Office Action Summary

10/695,178

RAULERSON ET AL.

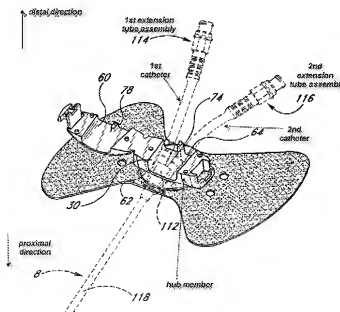
Bierman discloses a multiple catheter assembly comprising: a first catheter; a second catheter; a first and second extension tube 114, 116; a hub member 20 adapted to be releasably attachable to and around the first and second proximal end.

It has been held that the recitation that the hub member is "adapted to/capable of" performing a function is not a positive limitation but only requires the ability to so perform. It does not constitute a limitation in any patentable sense. In re Hutchison, 69 USPQ 138.
